REVISED RESPONSE TO REQUEST FOR ADDITIONAL INFORMATION

APR1400 Design Certification
Korea Electric Power Corporation / Korea Hydro & Nuclear Power Co., LTD
Docket No. 52-046

RAI No.: 222-8203
SRP Section: 11.05 – Process and Effluent Radiological Monitoring Instrumentation and Sampling Systems
Application Section: 11.5
Date of RAI Issued: 09/23/2015

Question No. 11.05-3

Figure 11.5-3C Monitor Assembly for Main Steam Line Effluent + N-16 Detectors

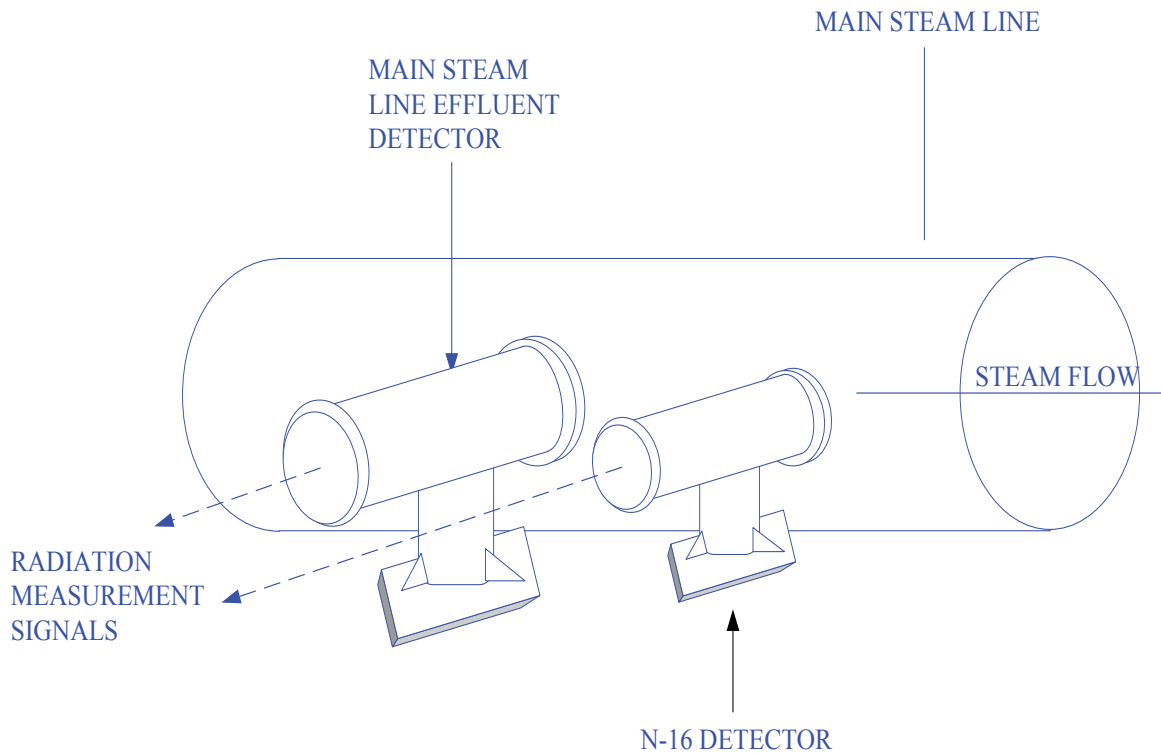
The ITAAC should address the sensitivity, response time, and alarm limit for the SG Tube leakage detection instrumentation. The staff requests the applicant to provide ITAAC for this system in the DCD Tier 1.

Please address this item and provide a markup for the proposed DCD changes.

This is required by RG 1.97 Rev.3 and the RMS purchase specifications require the supplier comply with this requirement. Please refer to DCD Tier 2, Subsection 11.5.2.2.5.m and Figure 11.5-3C.

m. Main steam line effluent and N-16 radiation monitors (RE-217, 218, 219, and 220)

Main steam line effluent monitors detect the radioactive effluent discharge to the environment through main steam safety valve (MSSV), main steam atmospheric dump valve (MSADV), and auxiliary feedwater pump turbine exhaust. The monitor performs the function required by NRC RG 1.97. The monitor also serves to quickly detect gaseous N-16 that exists in a leak from the primary to the secondary steam line. Depending on the gaseous PERMSS supplier, the two detectors (main steam line effluent and N-16) are assembled as one unit or could be enclosed in two separate units adjacent to each other.

One monitor on each of the four main steam lines is provided in the main steam line support structure. The monitors are placed as close as possible to the pipe as shown in Figure 11.5-3C, upstream of the main steam atmospheric dump valves and main steam safety valves.

Added

1. The main steam line (MSL) effluent monitor detects the radioactive effluent discharge through MSSV's, MSADV and AUX feedwater pump exhaust. This detector performs the function required by NRC RG 1.97.
2. The N-16 detector senses the SG tube leak.
3. Depending on the supplier, the two detectors (MSL and N-16) is assembled as one unit or the two are mounted as two separate but adjacent unit as shown above.
